S303-S159

**SERVICE****TECHNICAL BULLETIN**

Engine In Limp Home/Check Engine MIL –  
Water Ingress into Throttle Position Sensor –  
Service Action S159

MODEL 2003-04 MY  
S-TYPE R

ILLUSTRATION 1

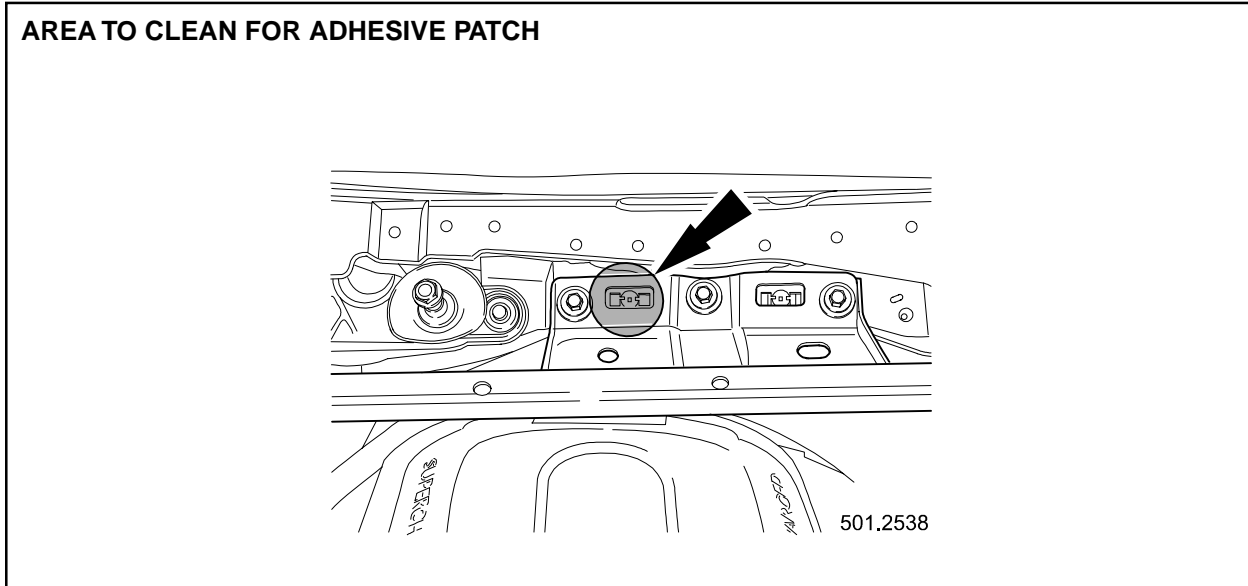
A concern has been identified on 2003-04 MY S-TYPE R vehicles within the above VIN range. It is possible that during washing of the vehicle, by car wash or jet wash, the water can run through the cowl panel grille-fixing hole into the throttle position sensor housing. This can result in the throttle position sensor failing to function, the engine management system defaults to 'limp home' mode, and a warning MIL is displayed.

- Clean the area indicated on the bracket of the suspension turret cross brace where it secures to the bulkhead (Illustration 1).

- Ensure the plastic insert is central in the rectangular hole of the brace.
- Remove and discard the backing from the adhesive patch and install the patch centrally over the right hand rearmost rectangular hole (Illustration 1) of the suspension turret cross brace.
- Reinstall the cowl panel grille, see Workshop Manual, JTIS CD ROM, section: 501-02, SRO 76.10.01.
- Remove fender protection kit and close hood and door.
